REVISED SITE PLAN CHANGES:

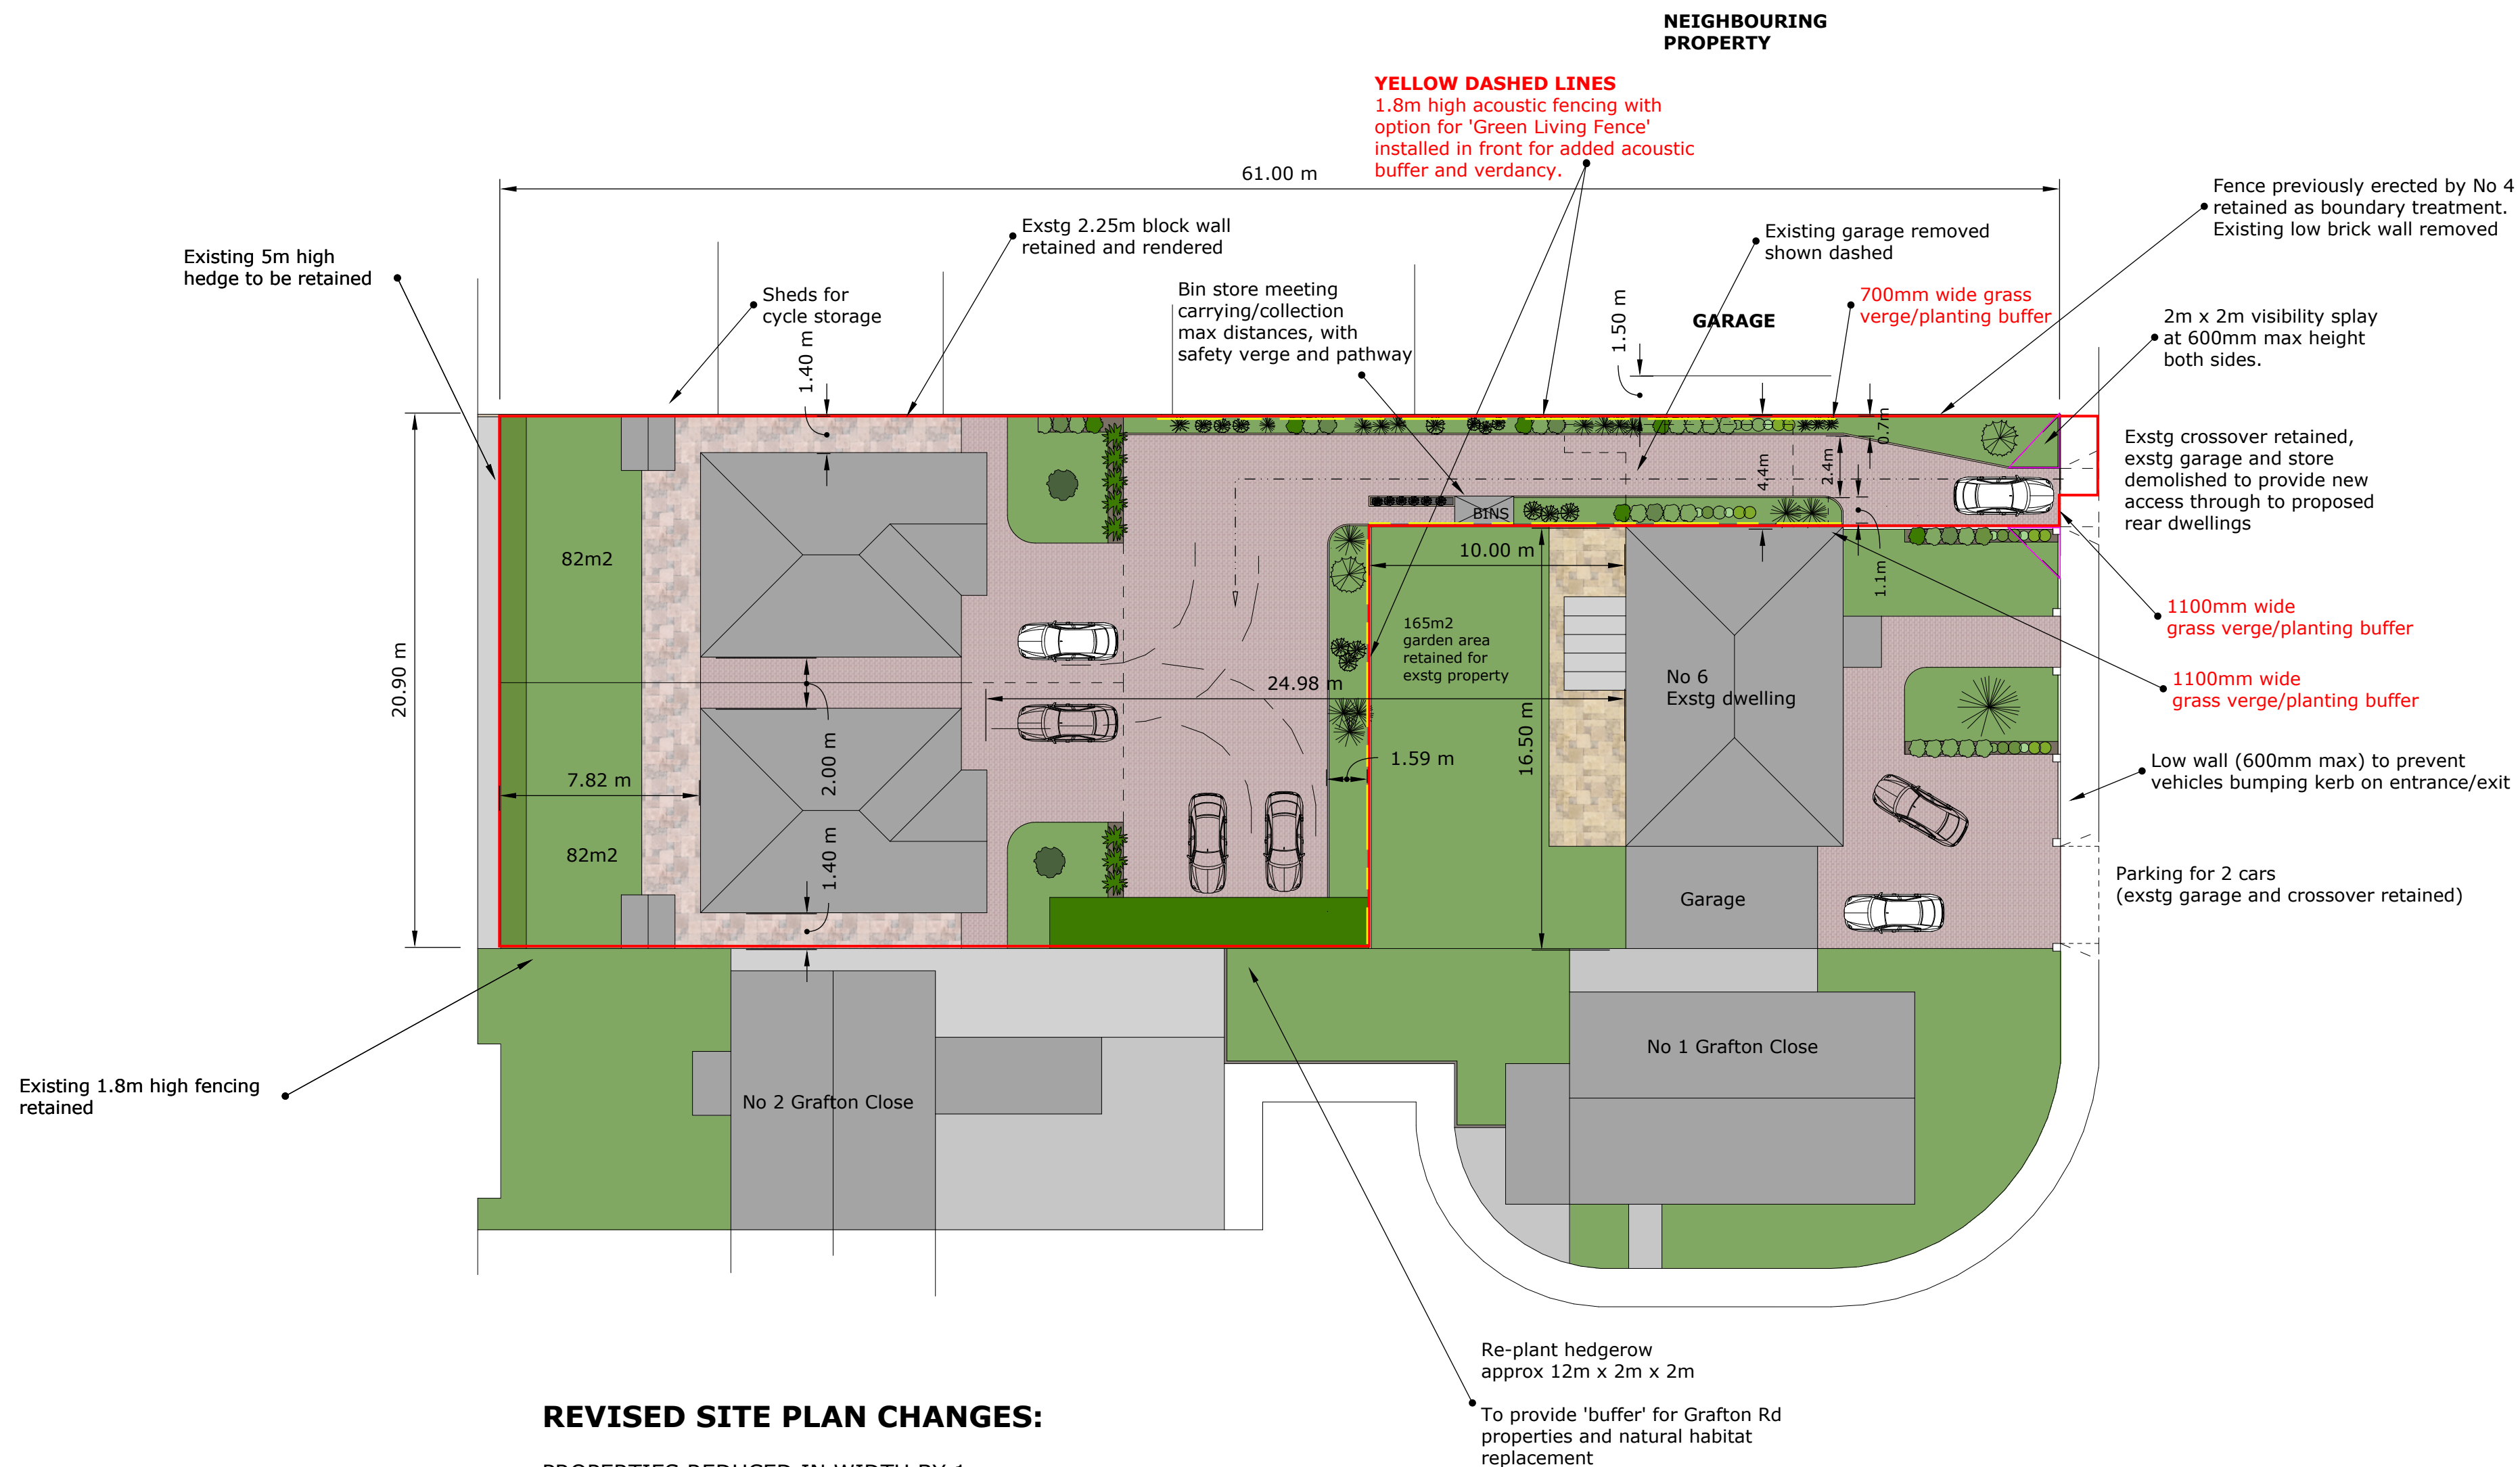
PROPERTIES REDUCED IN WIDTH BY 1m
DISTANCE TO SITE BOUNDARIES INCREASED FROM 900mm TO 1.4m
DISTANCE BETWEEN PROPERTIES INCREASED FROM 1m TO 2m

SEE ADDITIONAL NOTES ON PLAN ABOVE.
